RESPONSES OF THE BASIN ELECTRIC POWER COOPERATIVE TO EPA, NPS AND ENVIRONMENTAL GROUP COMMENTS REGARDING THE WYOMING DEPARTMENT OF ENVIRONMENTAL QUALITY'S PERMIT APPLICATION ANALYSIS FOR THE DRY FORK STATION

This document provides responses to the EPA, National Park Service (NPS) and the combined environmental group (Powder River Basin Resource Council, Wyoming Chapter of Sierra Club, Wyoming Wilderness Association, Wyoming Outdoor Council, Biodiversity Conservation Alliance, Western Resource Advocates, and Natural Resources Defense Council (collectively ENV)) comments on the Wyoming Department of Environmental Quality's (WDEQ) Permit Application Analysis to the Draft Prevention of Significant Deterioration (PSD) Permit to Construct for Basin Electric Power Cooperative's (Basin or Basin Electric) new Dry Fork Station.

Figure 1
Hawthorne Unit 5 – Hourly NO_x Emission Rates

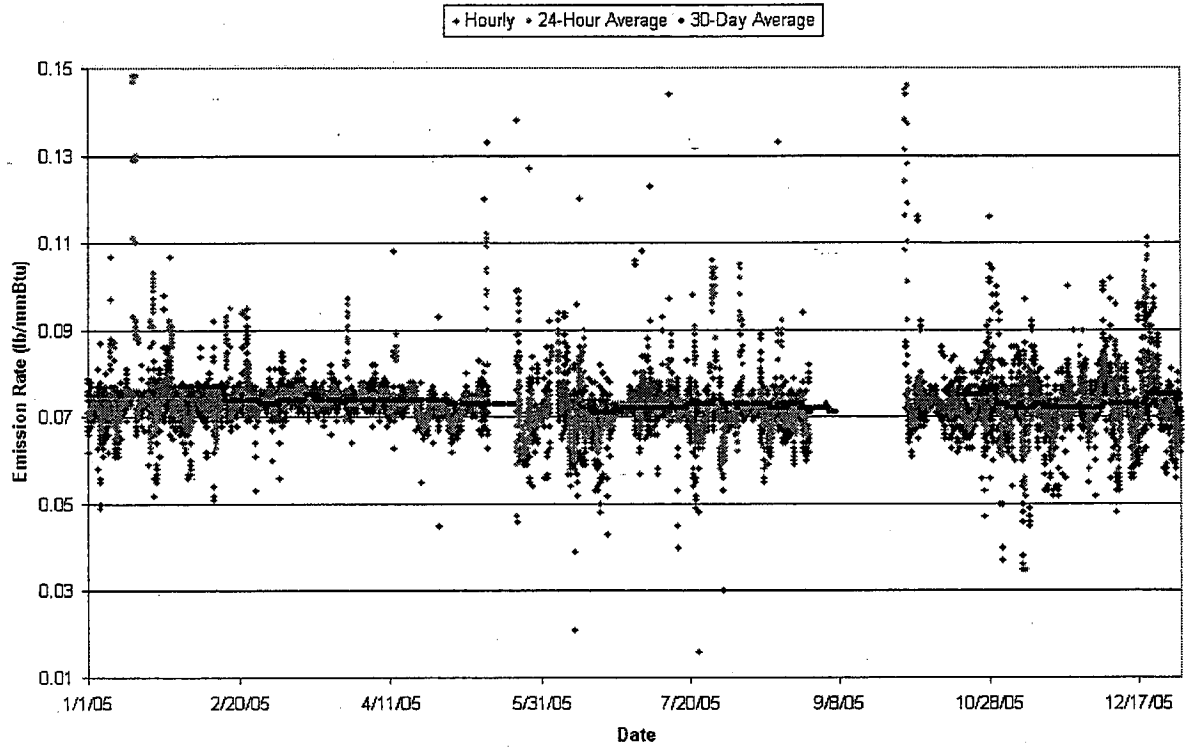
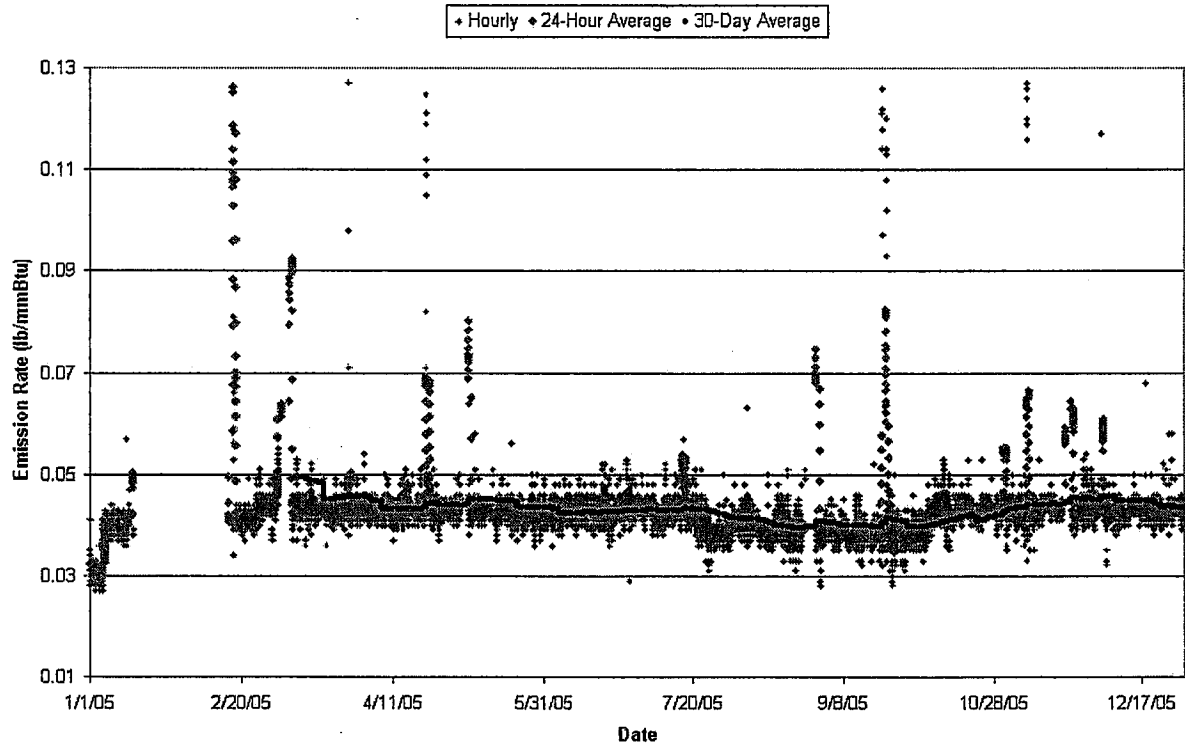
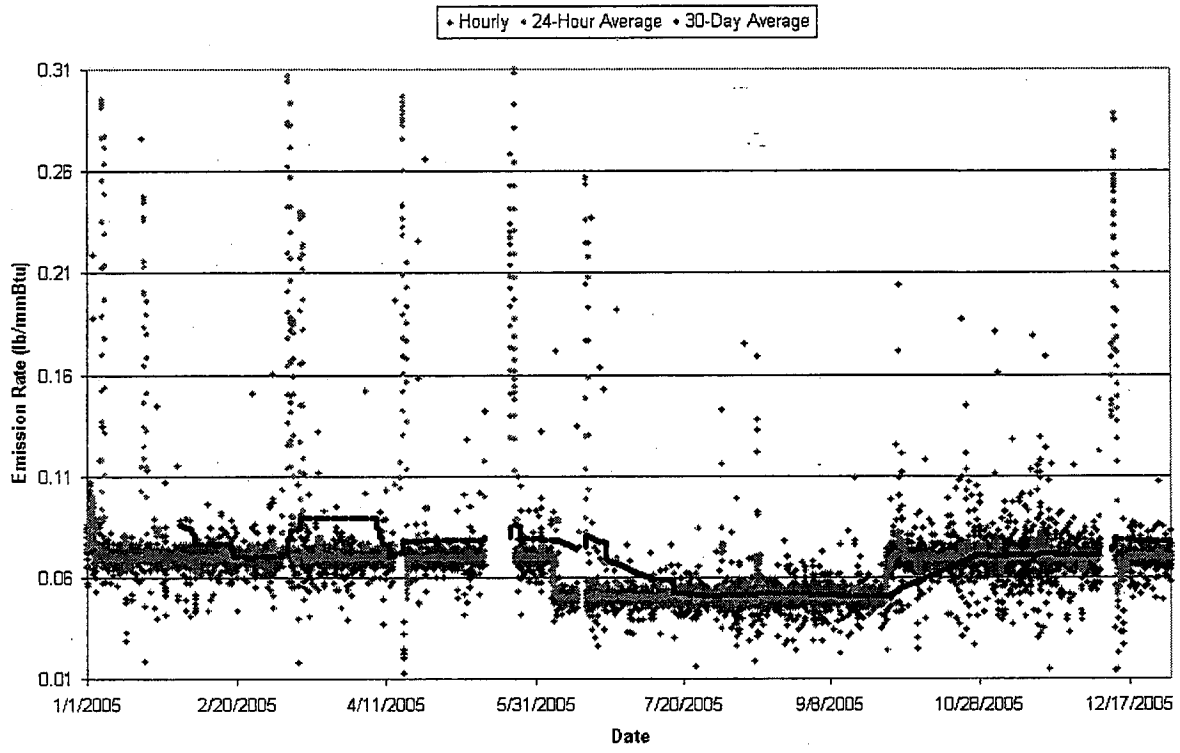
Short-term spikes in the controlled NO_x emission rate can be dampened by averaging NO_x emissions over a given period of time (e.g., 24-hour average, 30-day average, etc.). Figures 1, 2, and 3 show the hourly NO_x emission rates and the calculated rolling 24-hour and 30-day averages achieved in practice at each facility during 2005. Emissions data for each source were obtained from EPA's Clean Air Markets database available at: <http://cfpub.epa.gov/gdm/index.cfm?fuseaction=emissions.wizard>.

***Response:** The modeled NO_x emission rate was 266 lb/hr, 24-hour average, and the permit limit is 190 lb/hr, 30-day average. In order to comply with the 30-day limit, Dry Fork will need to comply with the 24-hour modeled rate. Sargent & Lundy, engineering consultants to Basin Electric on the Dry Fork project, evaluated the issue of whether compliance with the 30-day average would ensure 24-hour emissions less than 266 lb/hr, and concluded that it would. Sargent & Lundy, Memorandum regarding Proposed NO_x Emission Limits, June 16, 2007, (S&L NO_x Memo) Exhibit 14. This conclusion is based on empirical data showing the relationship between 24-hour and 30-day average emission rates at three coal-fired units similar to Dry Fork, and the lack of any practical operating scenarios in which Dry Fork could emit more than 266 lb/hr of NO_x and still comply with the permit limit of 190 lb/hr 30-day average. Details supporting this conclusion are presented in the discussion below, which draws on the S&L NO_x Memo. There is no need for a 24-hour NO_x limit because compliance with the 30-day limit will ensure that 24-hour emissions will be consistent with the emissions modeled for visibility impacts.*

Figure 4
Parish Unit 5 – Boiler Load Changes vs. Hourly NO_x Emission Rates

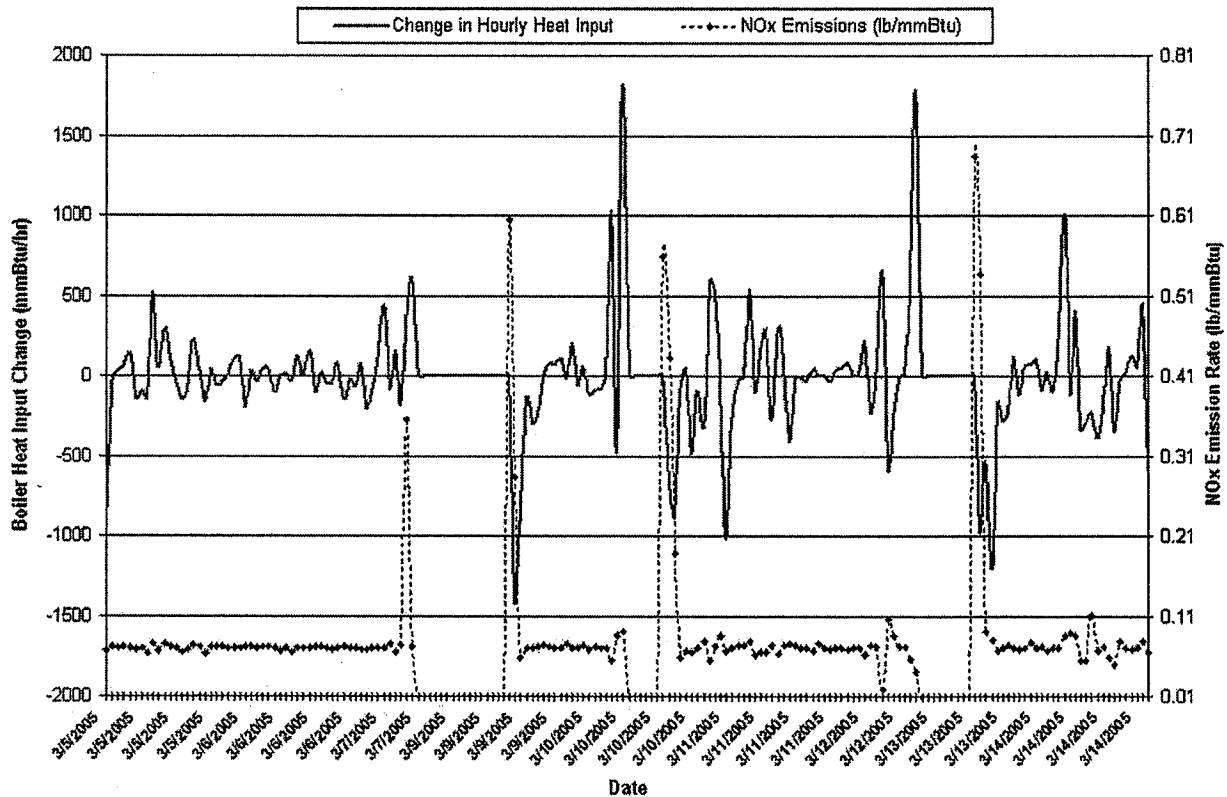
Figure 4 compares hourly boiler heat input changes (\pm lb/MMBtu) to the hourly NO_x emission rate (lb/MMBtu) for Baldwin Unit 2 between March 5 and March 14, 2005 (These dates were chosen because data showed high short-term NO_x emission rates). It can be seen that short-term spikes in the lb/MMBtu NO_x emission rate are often associated with relatively large drops in the boiler heat input. Therefore, even though the NO_x emission rate increases on a lb/MMBtu basis, there is no corresponding increase in the hourly mass NO_x emissions.

Figure 5
Hawthorne Unit 5 – Hourly SO₂ Emissions Data (2005)

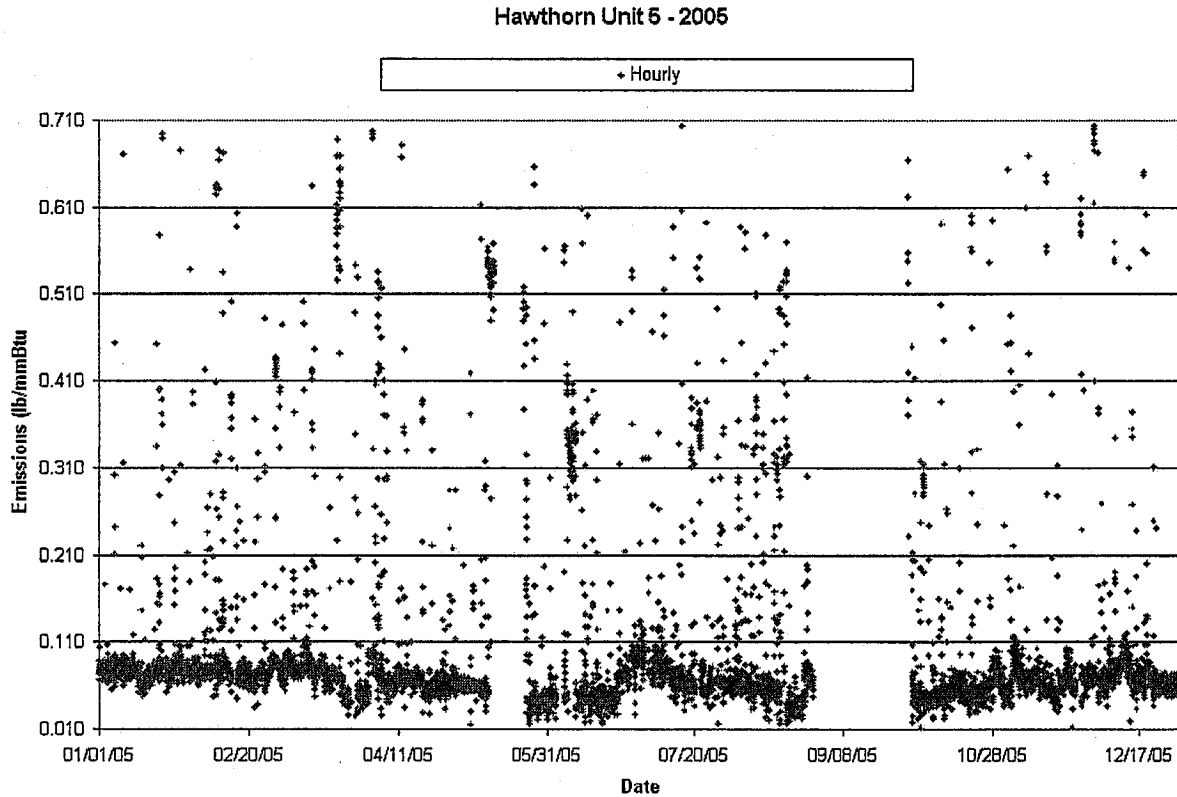
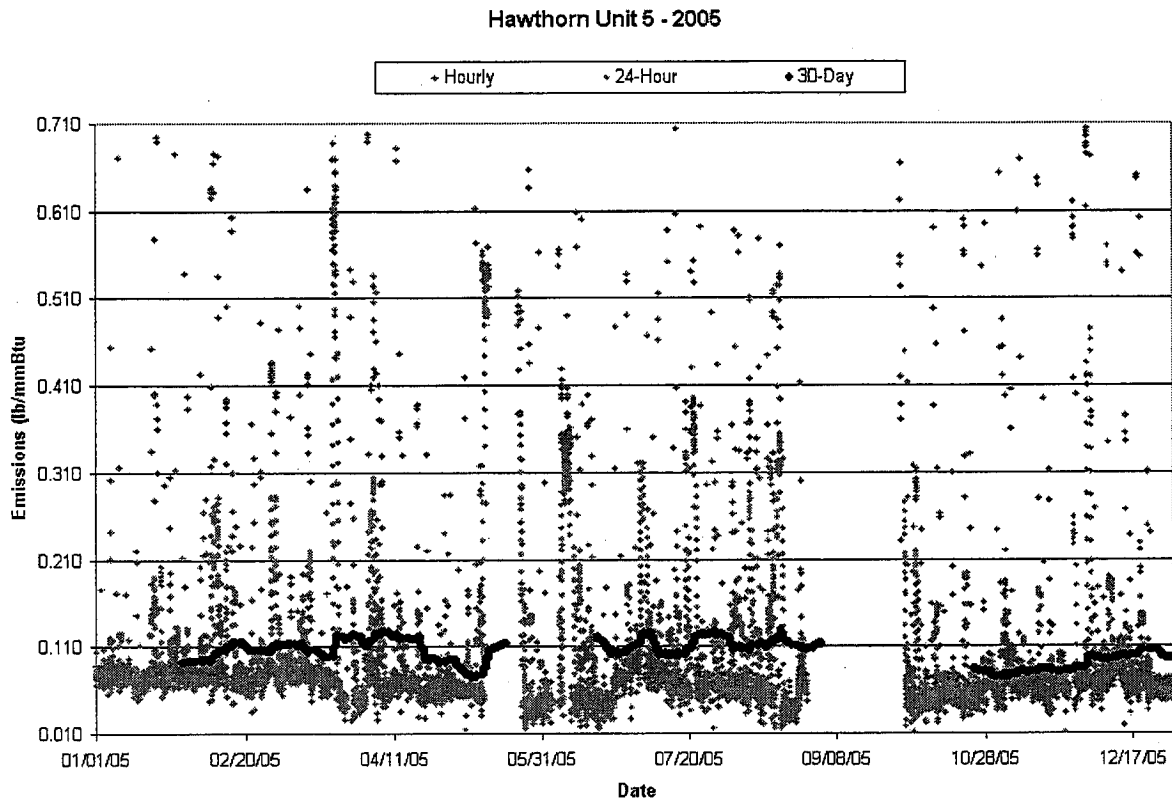
Figure 5 (below) shows the actual hourly emissions data reported by Hawthorn Unit 5 for 2005 (Emission data was obtained from EPA's Clean Air Market website: <http://cfpub.epa.gov/gdm/>). Emission control systems do not operate under steady-state conditions, and controlled emission rates are subject to short-term fluctuations and spikes. Hourly controlled SO₂ emission rates tend to fluctuate around the control system design point. Short-term spikes in controlled emissions might be caused by changes in boiler load, fuel characteristics, flue gas characteristics, and/or routine maintenance procedures. Short-term spikes in the controlled emission rate can be dampened by averaging emissions over a period of time. Figure 6 shows the same data, with the 24-hour and 30-day rolling averages. A summary of the removal efficiencies and the variation in the controlled emission rates achieved during 2005 based on several averaging times is provided in Tables 8 and 9.

Based on information available from equipment vendors and engineering judgment, the CDS DFGD system should be capable of achieving SO₂ removal efficiencies equivalent to those achieved with an SDA. Further, based on a direct project-specific comparison of both DFGD technologies, BEPC concluded the CDS design offered the following advantages over the SDA: (1) the CDS offers a better chance of complying with stringent SO₂ emission rates given the unique challenges at a mine-mouth plant with respect to variability in the fuel characteristics; (2) potential balance-of-plant impacts associated with operating either system so close to the performance target are potentially less significant with the CDS (i.e., the CDS should not experience wall wetting, scaling, plugging and the associated detrimental impacts on the baghouse); and (3) the CDS will not experience short-term emission spikes associated with routine atomizer changeouts and should be better suited to achieve stringent emission rates based on short-term averaging times. Therefore, BEPC is proposing dry FGD, designed as a CDS, as BACT for SO₂ control for Dry Fork Station.
